Project	<b>IEEE 802.16 Broadband Wireless Access Working Group</b> < <a href="http://ieee802.org/16">http://ieee802.org/16</a> >	
Title	<b>S/N cued scheduling support in the downlink for IEEE 802.16d MAC</b>	
Date Submitted	<b>2004-04-15</b>	
Source(s)	<p>Yunsang Park          Samsung Electronics          416, Maetan-3dong, Youngtong-gu          Suwon-si, Gyeonggi-do          Korea</p> <p>Yigal Leiba          Runcom Ltd.          Hachoma 2 St. 75655          Rishon Lezion, Israel</p>	<p>Voice: +82-31-279-5370          Fax: +82-31-279-5515  <a href="mailto:yunsang.park@samsung.com">yunsang.park@samsung.com</a>  <a href="mailto:yigall@runcom.co.il">yigall@runcom.co.il</a></p>
Re:	Sponsor Ballot Review of IEEE P802.16-REVd/D4-2004	
Abstract	Adding support for S/N cued scheduling in the downlink	
Purpose	Adoption	
Notice	This document has been prepared to assist IEEE 802.16. It is offered as a basis for discussion and is not binding on the contributing individual(s) or organization(s). The material in this document is subject to change in form and content after further study. The contributor(s) reserve(s) the right to add, amend or withdraw material contained herein.

## S/N cued sched

Figure aaa—DL Allocation Cue header format

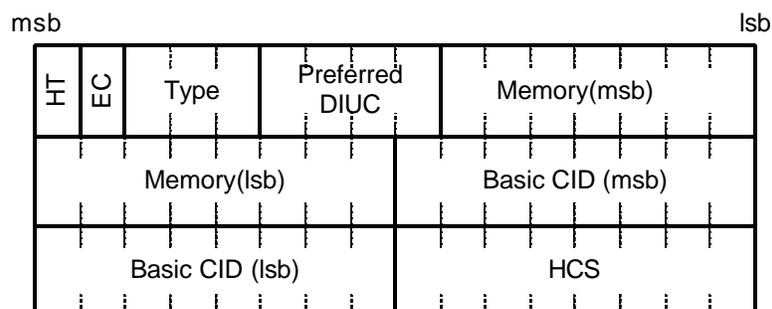
*Add a new section 6.3.2.1.3 with the following text:*

The DL Allocation Cue PDU shall consist of DL Allocation Cue header alone and shall not contain a payload. The DL Allocation Cue PDU shall only be supported by systems operating below 11GHz. The DL Allocation Cue Header is illustrated in Figure aaa.

- a) The length of the header shall always be 6 bytes.
- b) The EC field shall be set to 0, indicating no encryption.
- c) The CID shall be the basic CID of the SS.
- d) The Bandwidth Request (BR) field shall indicate the number of bytes requested.
- e) The allowed type for DL allocation cue is "011".

An SS receiving a DL Allocation Cue header on the downlink shall discard the PDU. The fields of the DL Allocation Cue header are defined in Table bbb. Every header is encoded, starting with the HT and EC fields. The coding of these fields is such that the first byte of a MAC header shall never have the value of 0xFF. This prevents false detection of the stuff byte.
